10 MWe Solar Thermal  
Central Receiver Pilot Plant

SOLAR FACILITIES DESIGN INTEGRATION

INDEPENDENT FEASIBILITY ASSESSMENT  
(RADL ITEM 4-4)

June 1979

Fig. T-1420-1C Design fatigue strain range,  $\epsilon_f$ , for Ni-Fe-Cr Alloy 800H

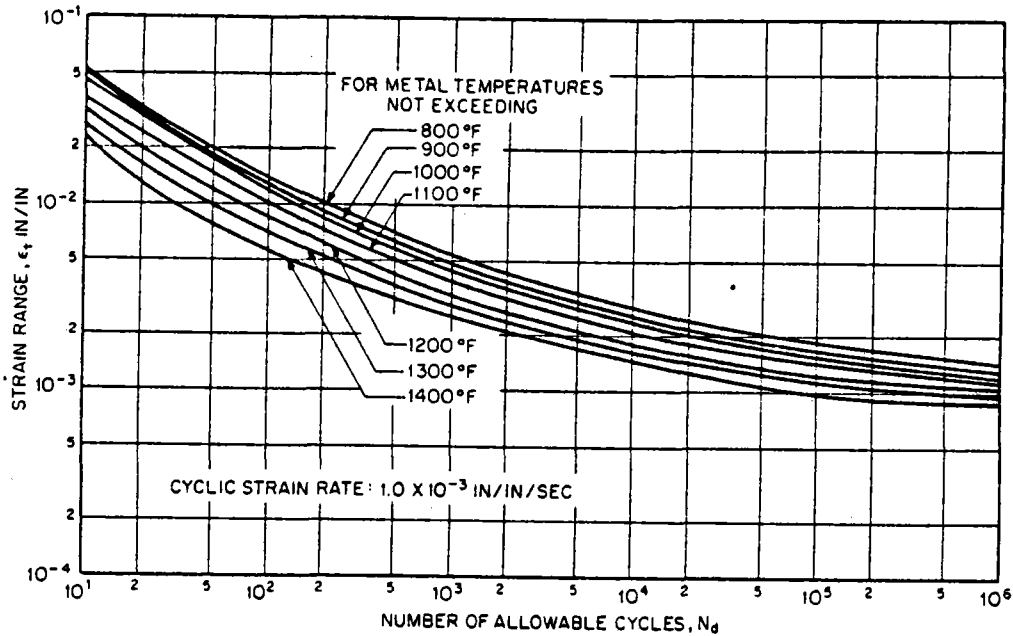
For example at 10,000 cycles and 1100°F the allowable strain range for Incoloy 800 is about 0.0045 from their curve. From T-1420-1C (Figure C) for 10,000 cycles for Incoloy 800H in the Code the allowable strain range would be 0.0021. The strain range of 0.0045 would only permit about 500 cycles. The values for stainless steel in the Code are in T-1420-1A (Figure F). The allowable strain range for 10,000 cycles is 0.0030.

Fig. T-1420-1A, 1B Design fatigue strain range,  $\epsilon_f$ , for 304 SS and 316 SS

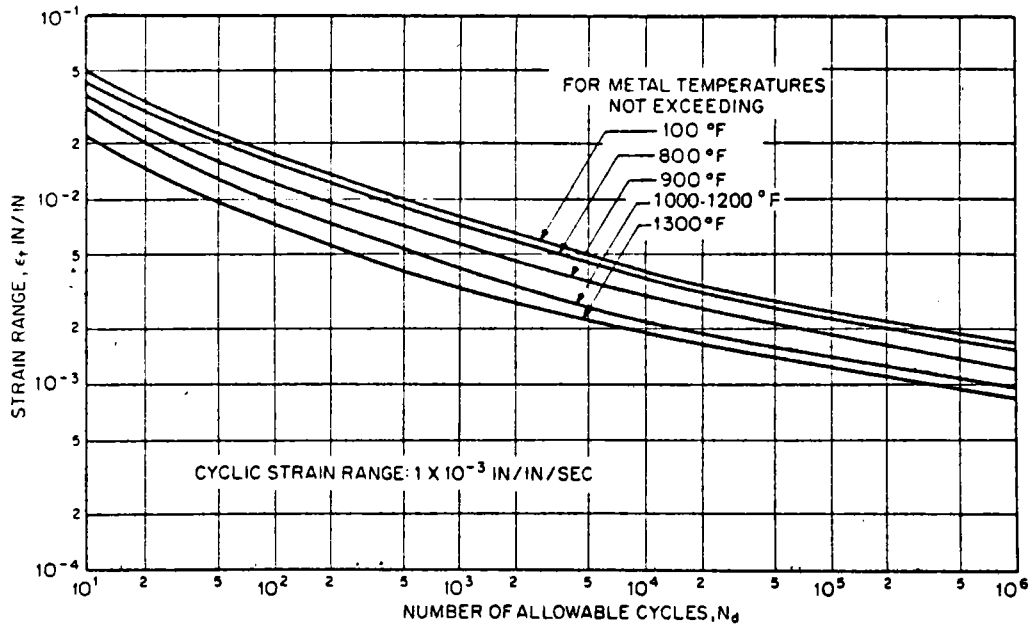
It would not be practical to develop such a curve for elastic analysis for Incoloy 800. Therefore, the curve for inelastic analysis should be developed. Such a curve was developed by Rocketdyne as shown in Figure E. This type of curve should be used if N-47 is to be followed with an inelastic analysis. It should now be reviewed in terms of all the data available since it has substantially higher allowable cycles than Incoloy 800H and for 304SS and 316SS (Figure F).
